Access Compliance Report Public Rights-of-Way (Curb Ramps)

Main Street: SPRING_ST Cross Street: RANCHO_SANTIAGO_BLVD Location: NW

ADA ID: RPAT210928091231 Ramp Type: Type 1 - Perpendicular Diagonal Initial Pass/Fail: Fail Overall Compliance: No Severity Score: 2

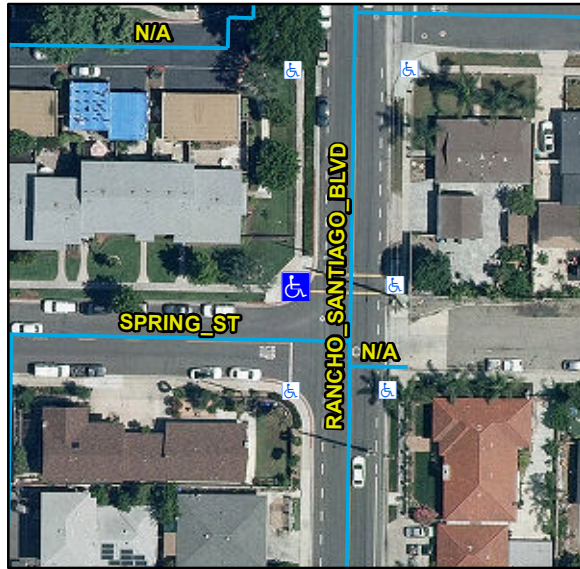
Compliance	Description	Data	Compliance	Description	Data
N/A	Ramp Length (in)	116	N/A	Flare Type LT	
Yes	Ramp Width (in)	48			N/A
Yes	Ramp Run Slope (%)	7.6	N/A	Flare Slope LT (%)	N/A
No	Ramp Cross Slope (%)	2.1	N/A	Flare Traversable LT	N/A
N/A	Landing Present	N/A	N/A	Flare Type RT	
N/A	Landing Length (in)	N/A			N/A
N/A	Landing Width (in)	N/A	N/A	Flare Slope RT (%)	N/A
N/A	Landing Run Slope (%)	N/A	N/A	Flare Traversable RT	N/A
N/A	Landing Cross Slope (%)	N/A	N/A	DWS Provided	N/A
N/A	Landing Movement Obstructed?	N/A	N/A	DWS Contrast	N/A
	Landing Movement Type	N/A	N/A	DWS Length (in)	N/A
N/A	Landing Shared	N/A	N/A	DWS Full Width	N/A
N/A	Clear Space	Yes	N/A	DWS Offset Left (in)	N/A
N/A	Clear Space To Crosswalk (in)	N/A	N/A	DWS Offset Right (in)	N/A
N/A	Marked Crosswalk 1	No	N/A	Marked Crosswalk 2	Yes
	Crossing 1 Direction	S		Crossing 2 Direction	E
	Marked Crosswalk 1 Width (in)	N/A		Marked Crosswalk 2 Width (in)	120

Remove & Replace Curb Ramp With Two New Directional Ramps or Equivalent.

R304.5.3, STD 1115
